# Planning Board File No. 20-0416

## 1501 Collins Avenue

Presentation by Law Offices of Kent Harrison Robbins, P.A.  
on behalf of Albert Lepage, Owner of Unit No. 801, 802 and 909,  
1500 Ocean Drive, Miami Beach, Florida

**RE: 1501 Collins Ave.-Traffic review, AAA#2603**

LOADING  
TRUCK  
OPERATION  
PLAN

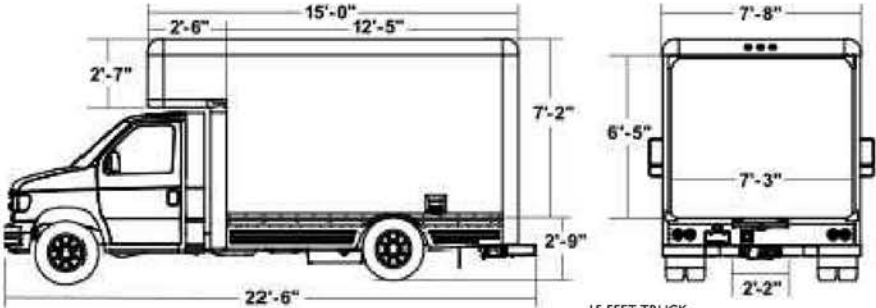
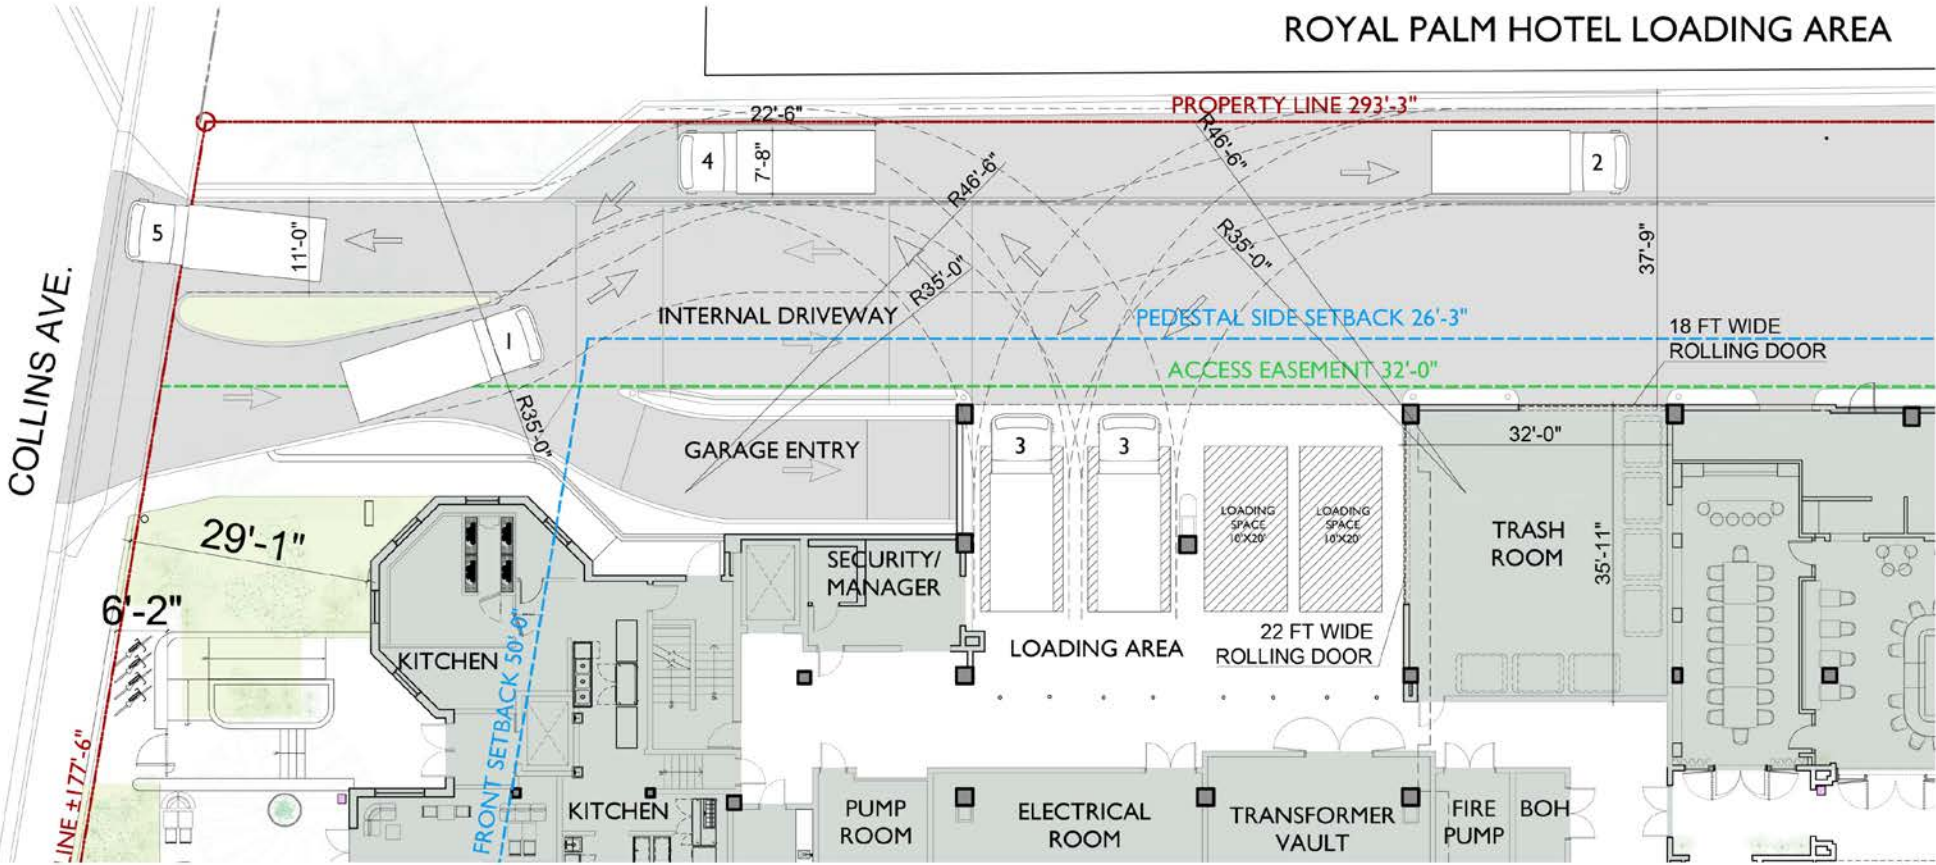
In regard to the loading geometrics, I observed that the very north side of the property is currently being used for angle parking. This angle parking will have to be eliminated completely to accommodate the maneuvering area of loading vehicles as well as trash trucks. The report assumes that the trucks using the loading space will not exceed 22'-6' x 7'-8' as specified on Attachment E, A2.00B Loading Truck Operation Plan.
